# EAST TOWN CROSSING FRONTAGE IMPROVEMENTS

## COVER SHEET

# EAST TOWN CROSSING SHAW ROAD IMPROVEMENTS

EAST TOWN CROSSING PIONEER WAY IMPROVEMENTS  
SEC. 26,35/ TWP. 20 N./ RGE. 4 E., W.M.

R0.0

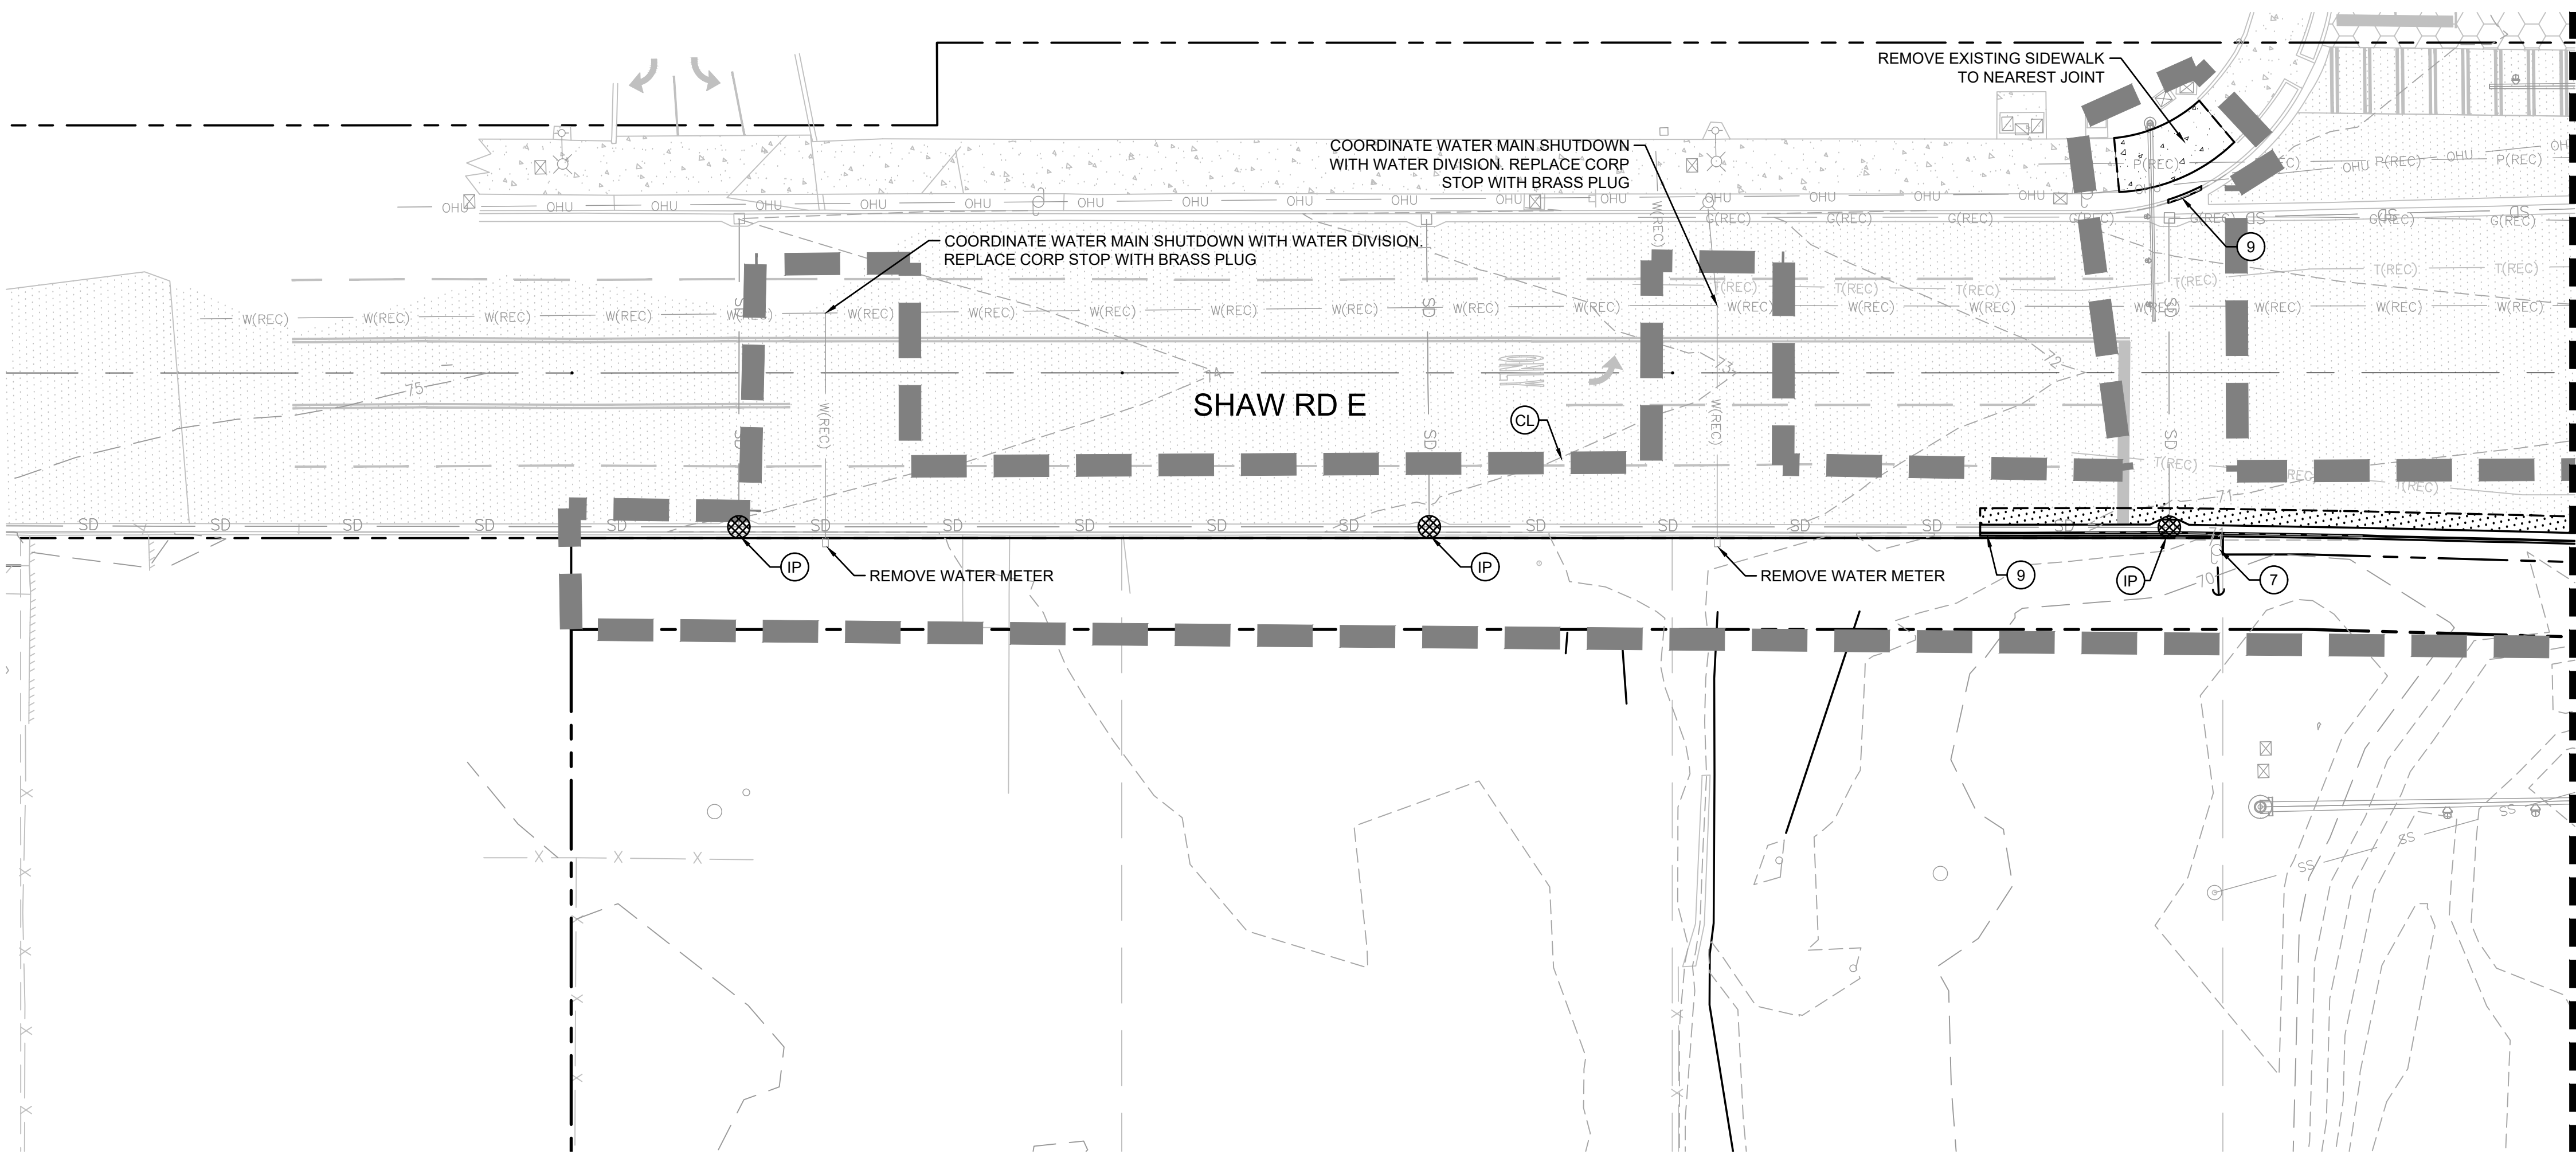
Provide DRAFT ROW dedication deed along Pioneer Way frontage, including sketch, on City Form. 34th road width from centerline, 10' planter, and 8' sidewalk. Once approved, record with the Pierce County Auditor. [Plans: Sht R0.0 of 21]

Included Draft ROW dedication in submittal package

**R1.0**

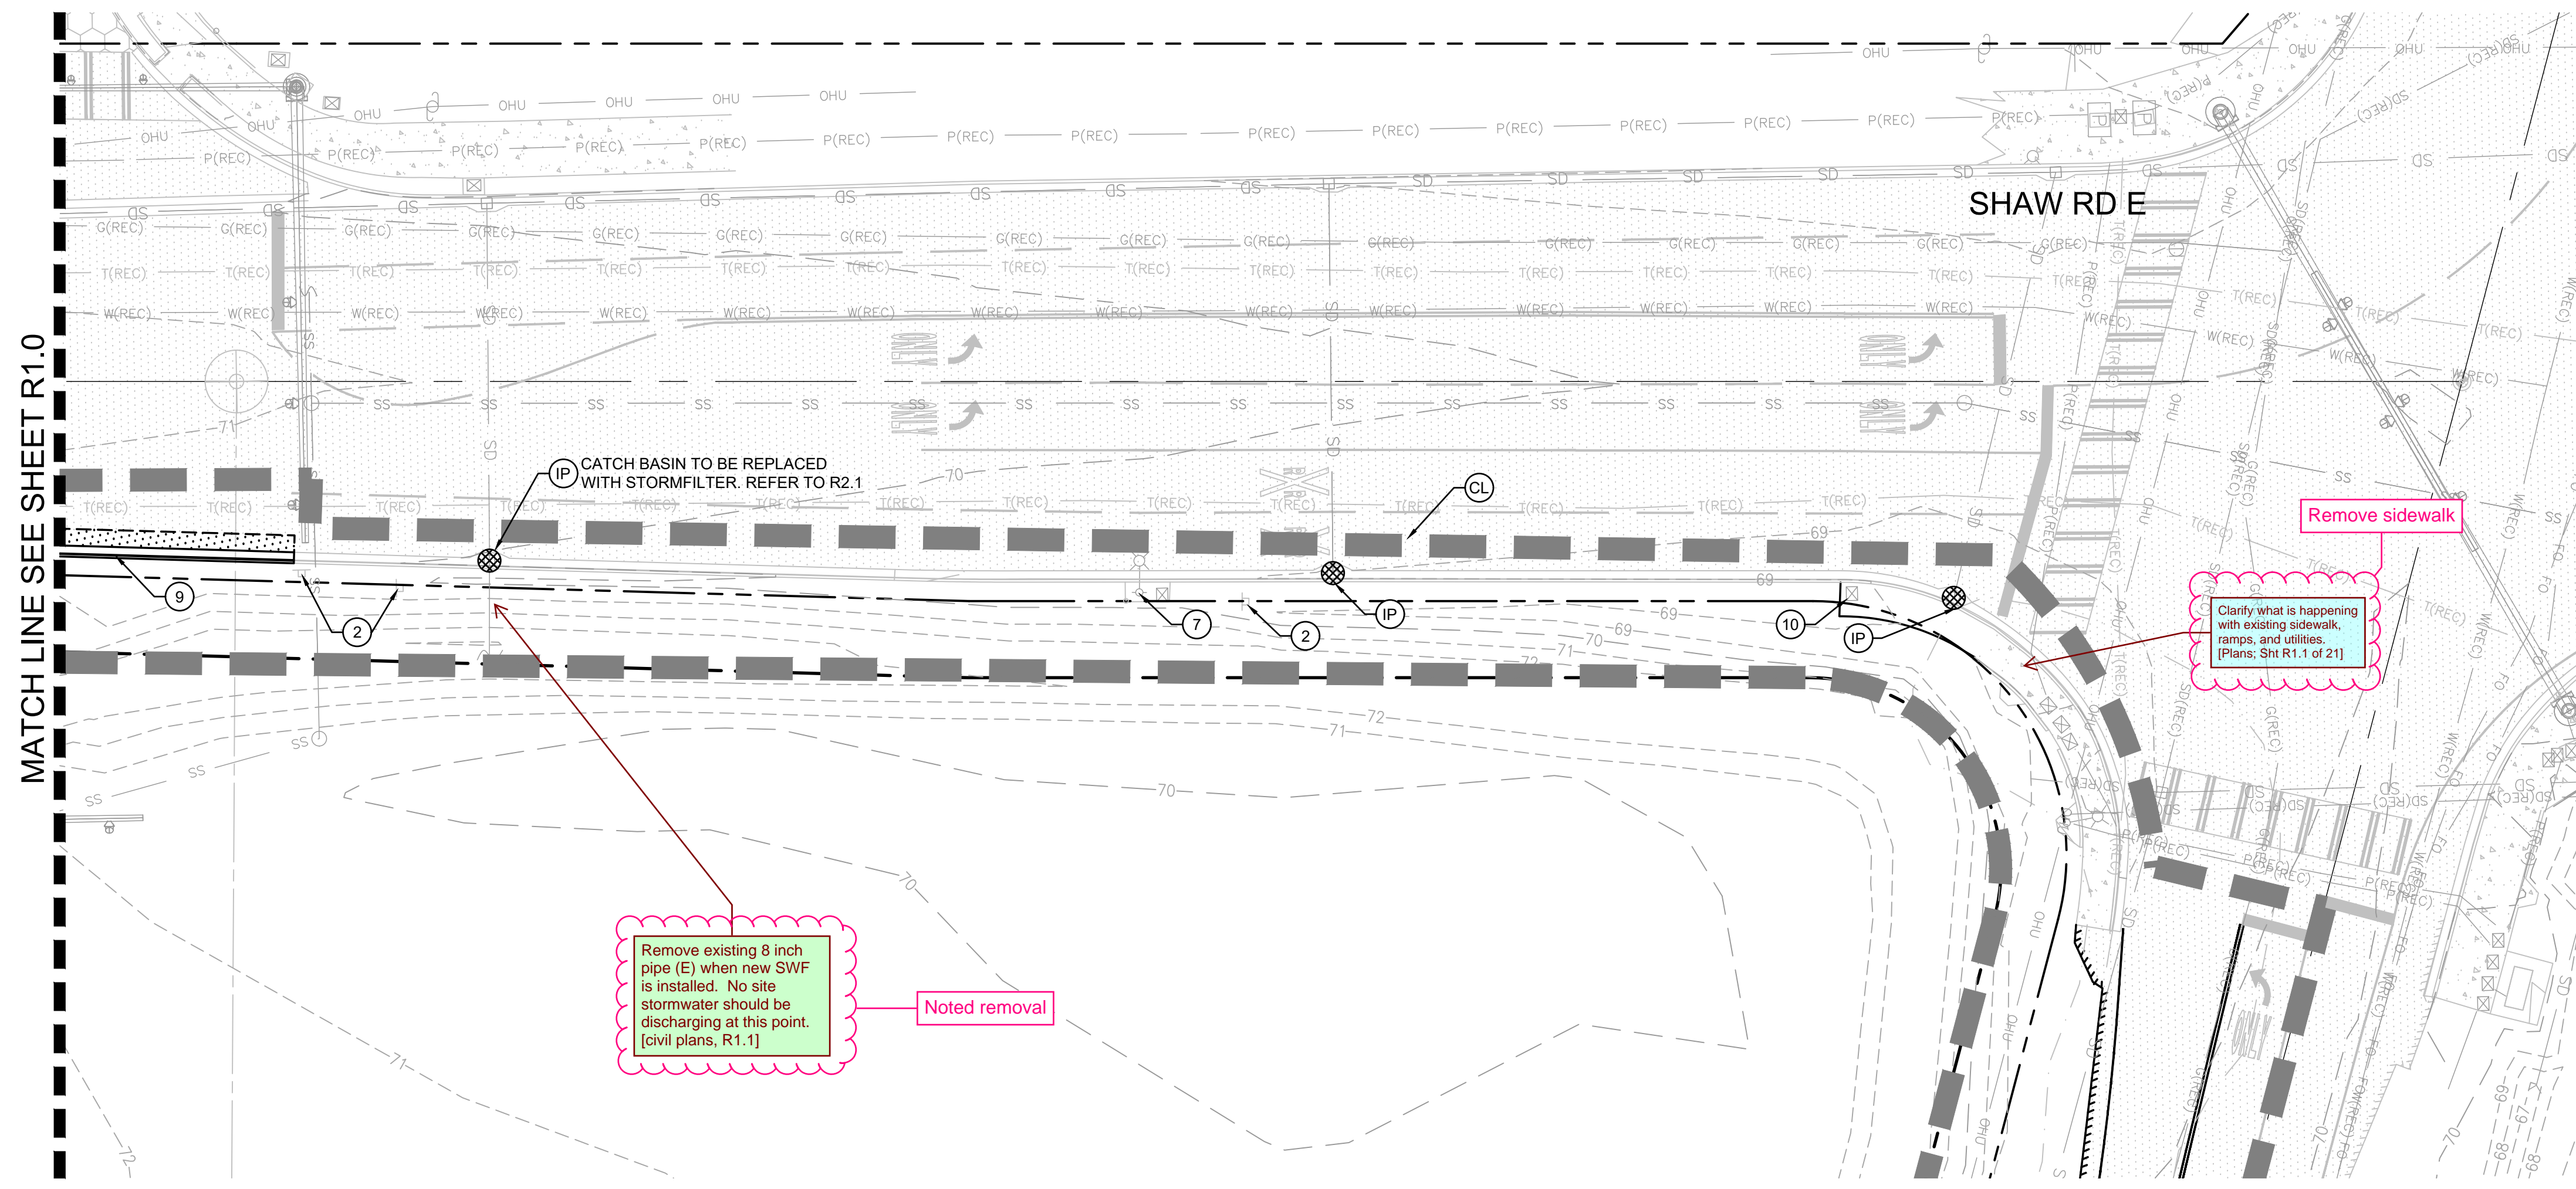
Add the following notes to the planset:  
-Existing public utilities that are in conflict with proposed frontage improvements shall be relocated as necessary to meet all applicable City, State, and Federal requirements.  
-Existing private utilities (power, gas, telcom, cable, etc...) that are in conflict with City maintained right-of way and utilities shall be relocated outside of the travelled road section, i.e., behind the curb under the sidewalk area or other location as approved by the City.  
[Plans: Sht R1.0 of 21]

Added as notes 3 and 4

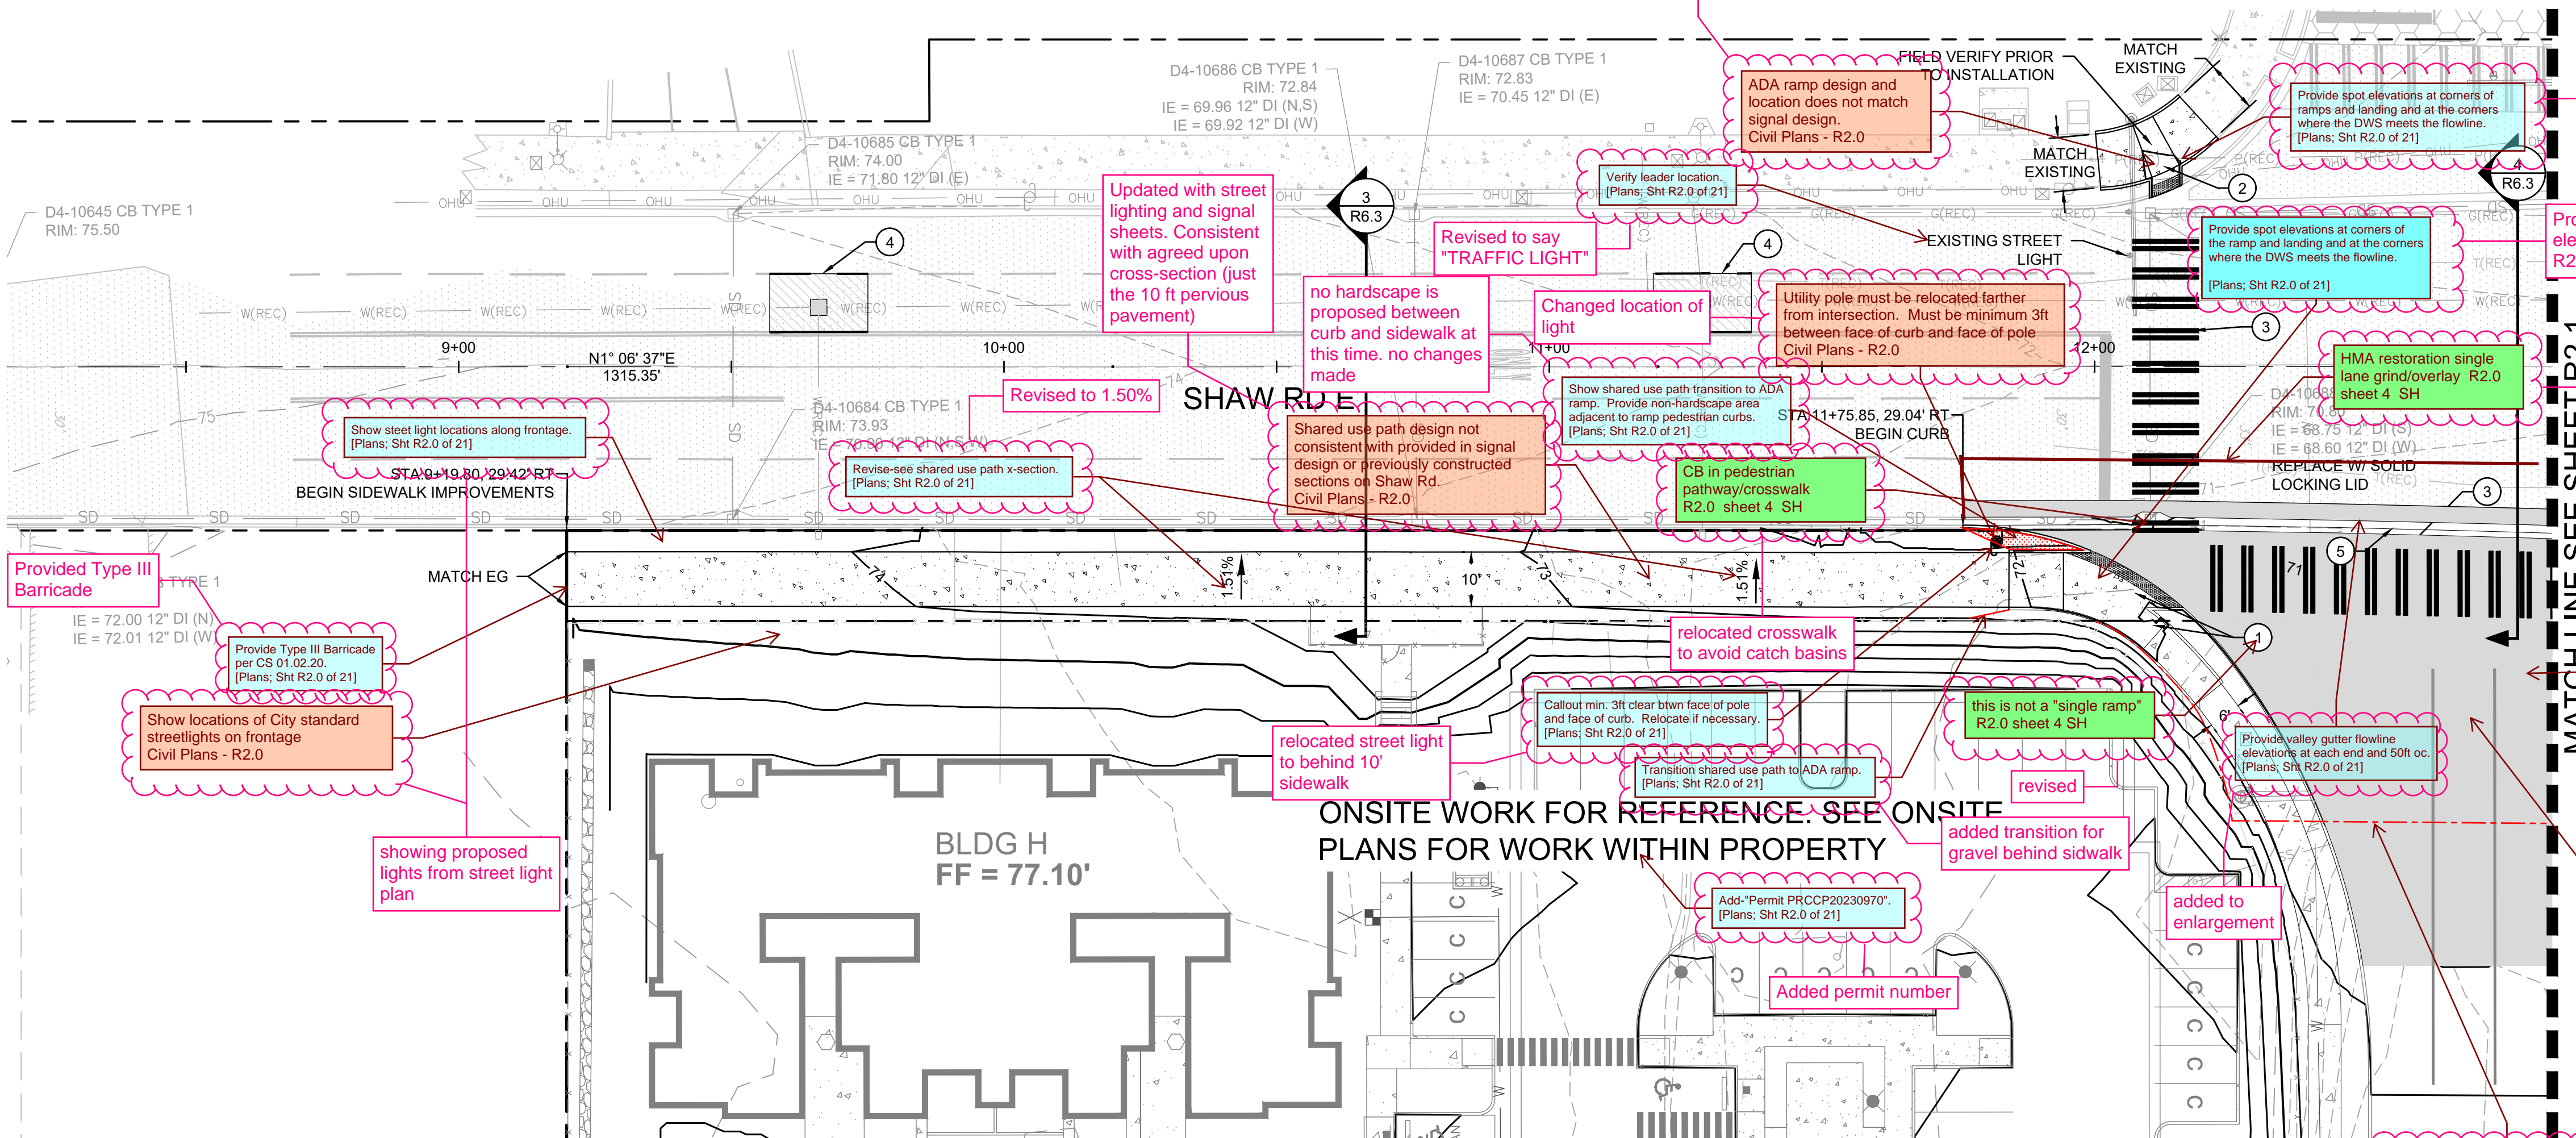
Add the following notes to the planset:  
-Existing public utilities that are in conflict with proposed frontage improvements shall be relocated as necessary to meet all applicable City, State, and Federal requirements.  
-Existing private utilities (power, gas, telecom, cable, etc.) that are in conflict with City maintained right-of way and utilities shall be relocated outside of the travelled road section, i.e., behind the curb under the sidewalk area or other location as approved by the City.  
[Plans, Sh. R1.1 of 21]

Added as notes 3 and 4
